to:	David Schaeffer Engineering Limited - Mr. Adam Fobert - afobert@dsel.ca
re:	Grading Plan Review Proposed Residential Development - 146 Mountshannon Drive - Ottawa
date:	July 24, 2013
file:	PG0267-MEMO.02
from:	Michael Laflamme

Further to your request, Paterson Group (Paterson) reviewed the following grading plan prepared by DSEL for the aforementioned residential development:

- Grading Plan - Drawing No. GP-1 - Project 09-396 - Revision 7 dated June 13, 2013

Grading Plan - Drawing No. GP-1 - Project 09-396 - Revision 7 dated June 13, 2013

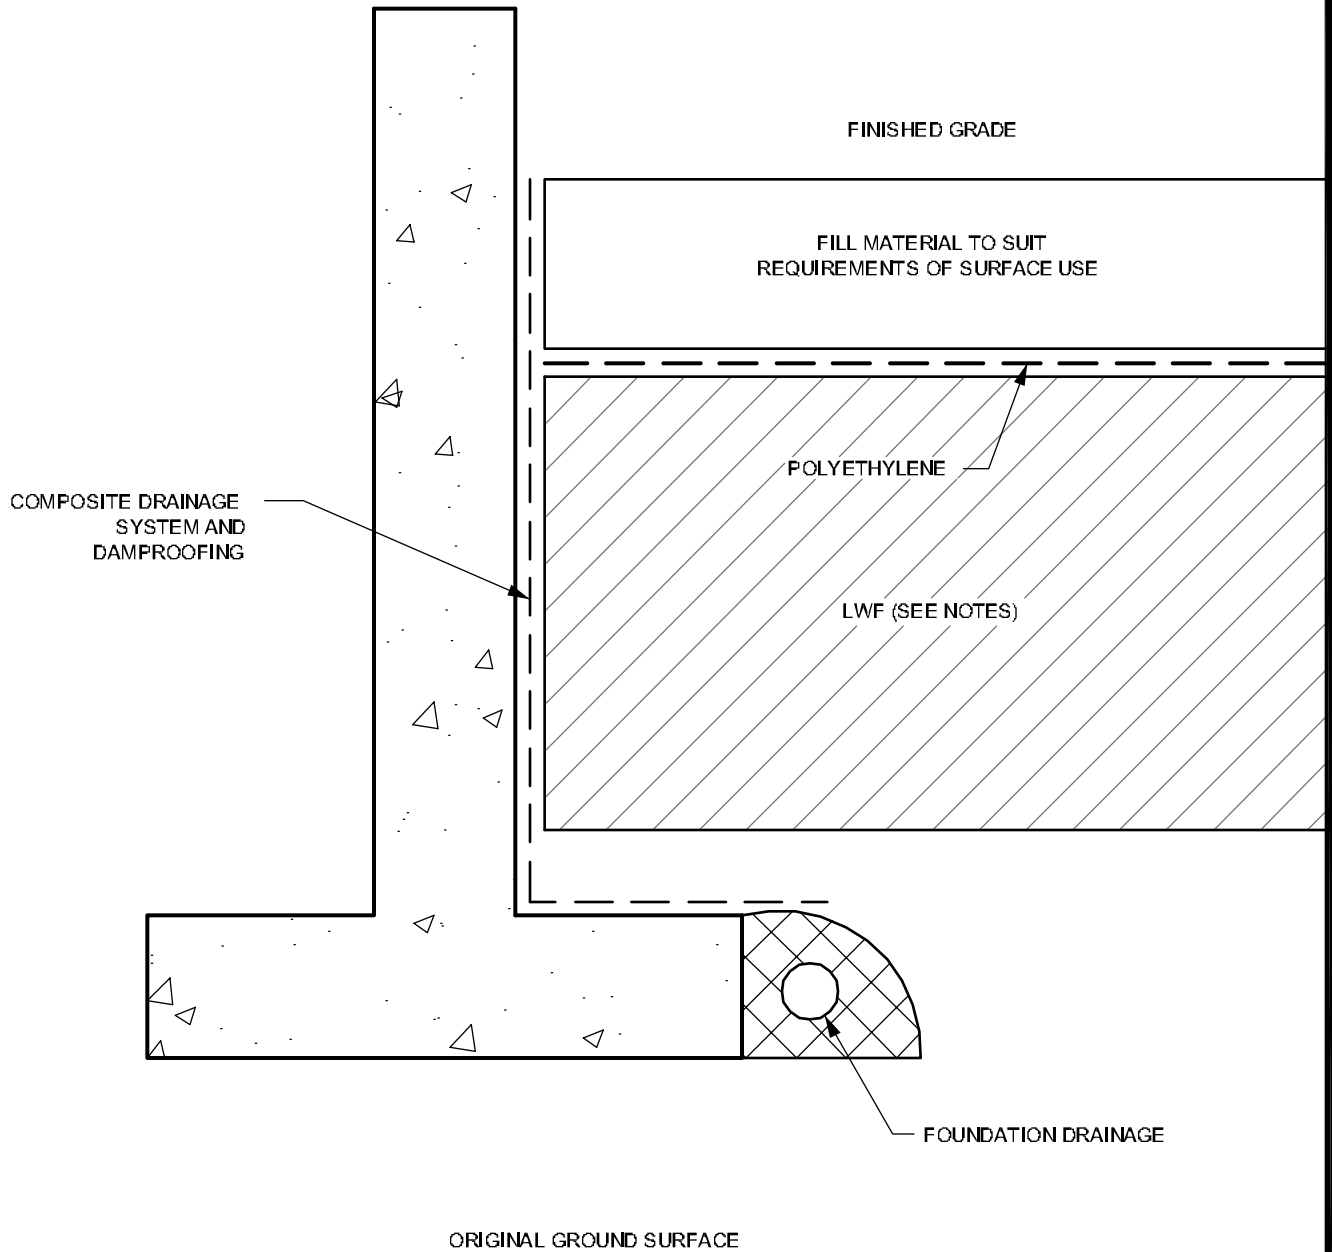
Based on our review, grading at several blocks have minor exceedances of our permissible grade raise recommendations provided in Report PG0267-2 dated March 17, 2010. However, no remedial measures, such as lightweight fill, are required due to the proposed grading with the exception of Blocks 9 and 12. Several units at Blocks 9 and 12 are located over an existing drainage ditch where grade raises of up to 2.4 m are required to achieved finished grading over the invert of the existing ditch. Lightweight fill is recommended to reduce the loading associated with the backfill due to the significant volume of in-filling required within the existing ditch at the front and sides of the blocks. Our lightweight fill recommendations for Blocks 9 and 12 are presented in Table 1 attached.

Upon further review of the subsoil conditions encountered at the test hole locations, a permissible grade raise restriction of 1.5 m is recommended for grading around the proposed buildings. It is expected that the underlying silty clay deposit can tolerate a higher grade raise than previously reported without excessive settlement (ie.- less than 25 mm total settlement) occurring. Several properties of the silty clay deposit encountered on site are favourable for significant grade raises without excessive settlement, such as silty clay layer depth (which extended to a maximum 6 m depth) and firm to stiff consistency of the deposit. These factors were considered in the updating of the permissible grade raise restriction. It should be further clarified that the permissible grade raise restriction noted within our Report PG0267-2 dated March 17, 2010 was a conservative value, which was expected to be sufficient for the proposed development at that time. It should be further noted that the proposed grade raises for the roadways throughout the development are considered acceptable from a geotechnical perspective and no remedial works are required from a geotechnical perspective to accommodate the proposed grade raises.

1. USE EPS19 BELOW GARAGE, FRONT PORCH AND DRIVEWAY
2. USE EPS15 BELOW LANDSCAPED AREAS
3. MINIMUM GRANULAR THICKNESS OVER LWF SHOULD BE AS FOLLOWS:

FRONT PORCH	150mm OF OPSS GRANULAR A
GARAGE	300mm OF OPSS GRANULAR A
DRIVEWAY	450mm OF OPSS GRANULAR A
4. PLACEMENT OF LWF SHOULD BE ON A LEVELED SURFACE (SAND CAN BE USED TO PROVIDE AN ADEQUATE LEVELLING SURFACE).
